## Item 11 - Correspondence

**Subject:** Creekside at Cabin Branch: Site Plan No. 820200160

**Figure 4.** Small watershed stream health rankings in relation to impervious surface cover, watershed tree cover, and riparian buffer zone tree cover.

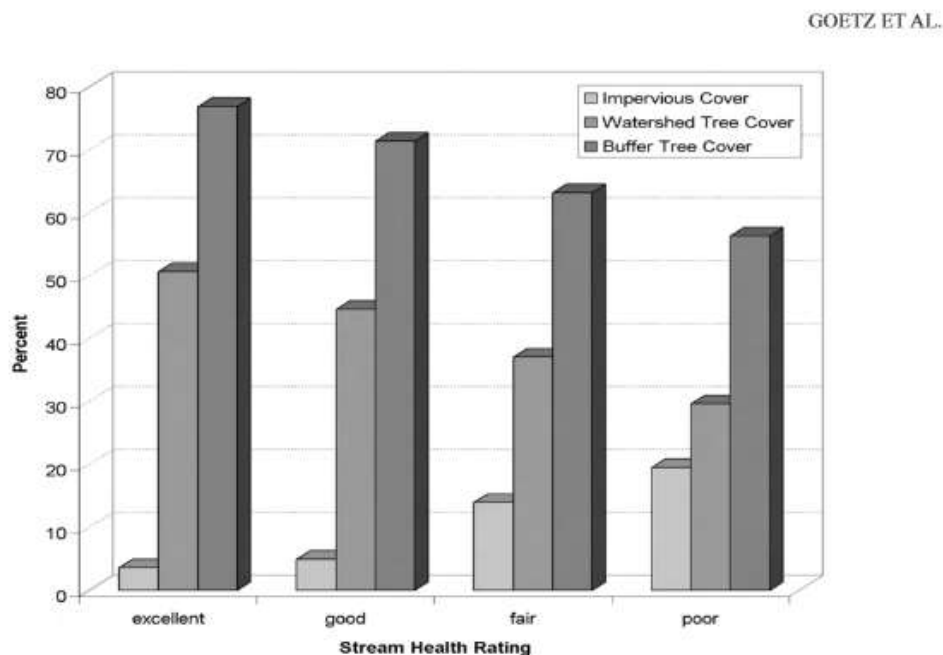
Imperviousness is important in two ways: it directly harms healthy streams as documented by Scott Goetz and others, and it’s an indicator of the damages wrought by the *Urban Stream Syndrome* – the urbanization of rural watersheds.
